BELL BEND NUCLEAR POWER PLANT
BBNPP PLOT PLAN CHANGE COLA
SUPPLEMENT, PART 2 (FSAR); SECTION 2.3
BNP-2011-030 Docket No. 52-039

Response to RAI #94 Question 02.03.03-3 (Partial) for COLA Part 2 (FSAR), Chapter 2.3

Question 02.03.03-3:

Figure 2.3-64 {Topography Within 1-Mile of the BBNPP Site}

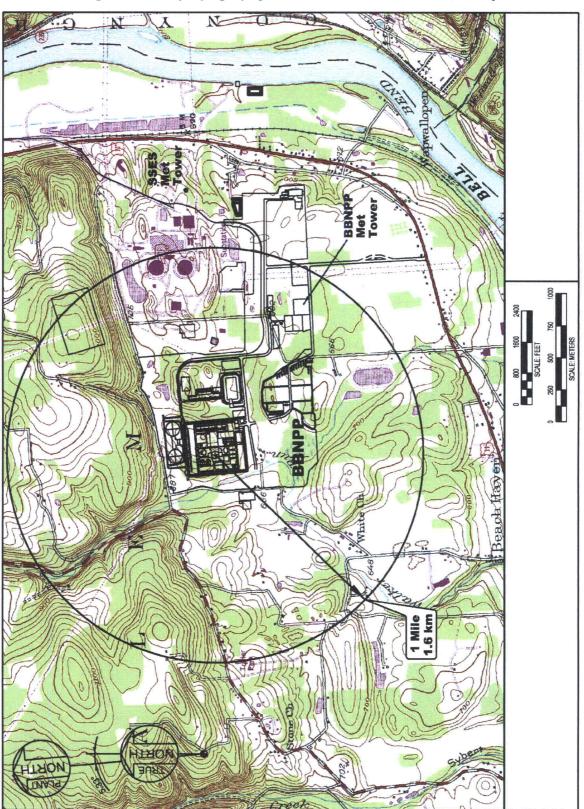
As stated in Standard Review Plan (SRP) Section 2.3.3, SRP Acceptance Criteria (1a) and (1b), and Regulatory Guide 1.206, Section C.I.2.3.3, the staff requests that additional information be added to FSAR Section 2.3.3 regarding the physical parameters of the potential obstructions to the pre-operational and operational towers. Listed obstructions should include the salt storage building, reactor building, turbine building, domestic water storage tank, emergency diesel generator (EDG) building, service and administration building, and parameters should include grade elevation, height, width, distance and wind direction sector relative to meteorological towers, including width at top and bottom of cooling tower. Also, for the proposed operational tower, please include both the northern and southern tree lines and grade elevations for each obstruction listed in the tables.

Table 2.3-185, Potential Man-Made Obstructions for Air Flow for the BBNPP Meteorological Tower, will be added to the FSAR. Figure 2.3-64, Topography Within 1-Mile of the BBNPP Site, and Figure 2.3-65, Topography Within 5-Miles of the BBNPP Site, will be replaced with updated figures. The new table and replacement figures are shown below.
